LIMERICK GENERATING STATION UNITS 1 & 2  
ENVIRONMENTAL REPORT - OPERATING LICENSE STAGE  
REVISION 8 PAGE CHANGES

The attached pages, tables, and figures are considered part of a controlled copy of the Limerick Generating Station EROL. This material should be incorporated into the EROL by following the instructions below.

FIGURE E291.6-1

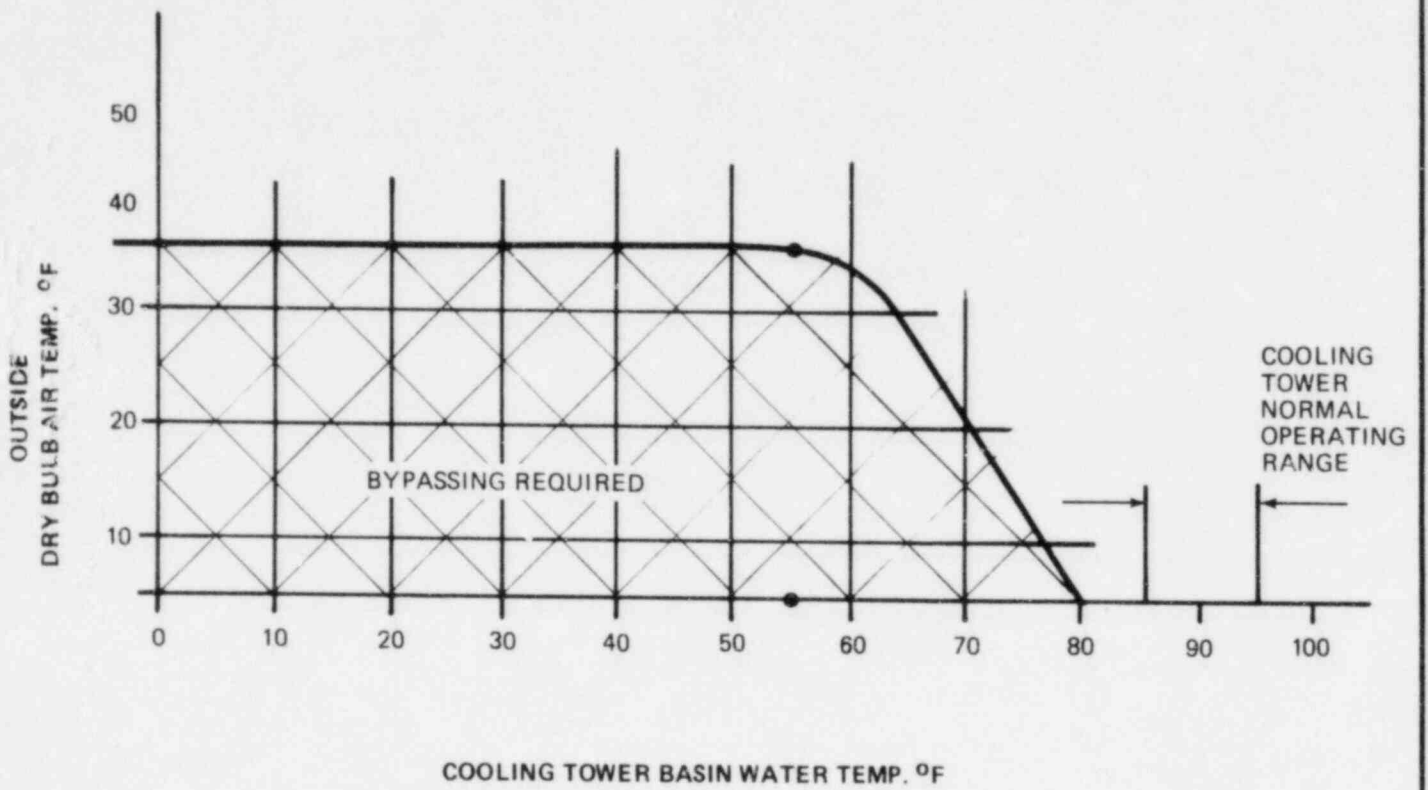
QUESTION E291.6 (Section 3.4.2)

A statement in Section 3.4.2 mentions use of a cooling tower bypass line for the circulating water. Indicate whether the cooling towers are expected to be operated all year round. Describe those conditions and their expected frequency and duration under which the towers would be bypassed.

The cooling towers are expected to operate on a year-round basis. The only time the bypass would be used would be during a winter startup after an extended shutdown, when the ambient air temperature and the basin water temperature meet the conditions shown in Figure E291.6-1. When the basin water temperature reaches the limit specified in Figure E291.6-1, bypass operation would cease and normal tower operation would resume. This type of operation is expected to occur less than 3 times a year for a period of approximately 30 hours each time.
